Name of Applicant	Proposal	Expiry Date	Plan Ref.
Bellway Homes Ltd (Chris O' Hanlon)	<p>Variation of condition 25 of planning permission APP/P1805/W/20/3245111 allowed on appeal 09/02/2021 (LPA 16/1132):</p> <p>FROM: No part of the development shall be occupied until the junction of Fox Lane/ Rock Hill has been altered in accordance with the scheme for a roundabout shown on the plan Fox Lane/ Rock Hill schematic ref 7033- SK-005 revision F</p> <p>AMEND TO: No more than 49 dwellings (of which, no more than 30 shall be for private sale and no more than 19 shall be for affordable housing) shall be occupied until the junction of Fox Lane/Rock Hill has been altered in accordance with the scheme for a roundabout shown on the plan Fox Lane/Rock Hill schematic scheme ref 7033- SK-005 revision G and ancillary drawings 7033-s278-701 rev C02, 2015804 AGE- ZZ-XX-DR-X-0002, 0003, 0004, 0005, 0006 REV C02.</p> <p>Land At, Whitford Road, Bromsgrove, Worcestershire,</p>	05.08.2025	25/00529/S73

RECOMMENDATION: That planning permission be **GRANTED**

Current consultation [25/00529/S73]

Figure 4- 2024 Baseline Recorded Queue Lengths

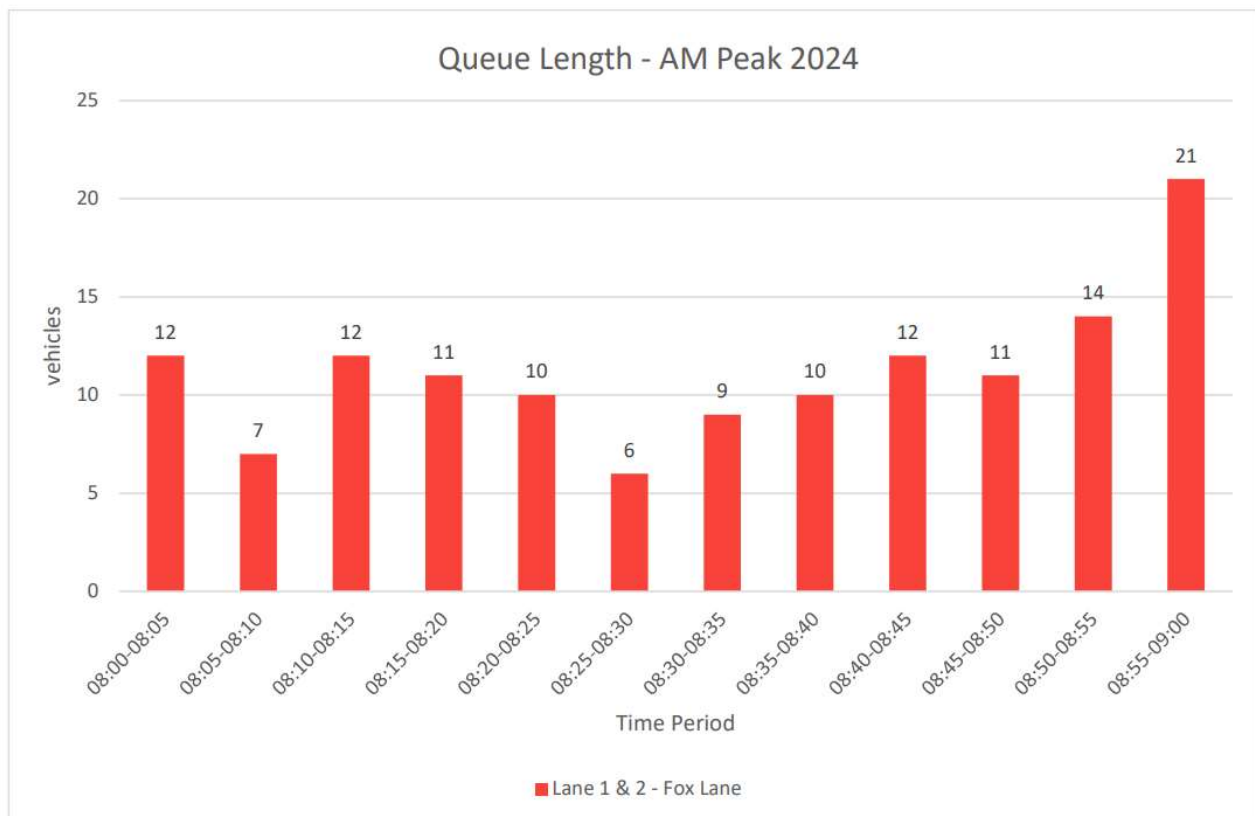
The Highway Authority has reviewed the performance of the model to replicate observed queues. The Applicant presents an assessment of the observed queuing on Fox Lane in Technical Note 4. Figure 4 [2024 Baseline Recorded Queue Lengths] is extracted and replicated below: -

As shown, the between 8:00 and 8:55 the maximum queue observed was 14 vehicles which results in 77m queue based on a 5.5m PCU value per vehicle and average being 11 vehicles. The queue is then observed to increase to 21 vehicles between 8:55 to 9:00 time period. The 21 vehicle queue at 8.55am which only occurs in that one 5 minute period appears to be an anomaly compared to the rest of the recorded hour, a review of the camera footage has been completed which indicated this was just a short period of queueing that was cleared within 1 minute.

While the model forecasts 8 vehicles in the queue, the average maximum recorded queue over the AM hour is 11 vehicles, whilst the average queue record at the end of each five-minute period over the hour is 4 vehicles. As such, the model queue forecast of 8 vehicles provides an appropriate balance between representing the maximum queues and also recognising the fluctuations in queuing across the hour. This must be considered as there are clear periods

across the hour where there are no queues present at the junction, and artificially 'throttling the junction to reflect a maximum queue in likely to lead to unrealistic results.

JUNCTIONS 11 modelling software is a widely used software for analysing priority junctions. But like all models, there are limitations. One of these is the ability of the model to accurately represent actual fluctuations in traffic volume, as evidenced by the queue survey data provided. The model is also not able to quantify the impacts of redistribution/ demand responses as a result of congestion on the network. The Highway Authority does not accept a PCU value of 5.5m and instead has used a PCU value of 5.75m.

Based upon the submission, the Highway Authority does not consider the model an unrealistic representation of network conditions where congestion, queuing and delays do occur and are shown to in the model outputs.
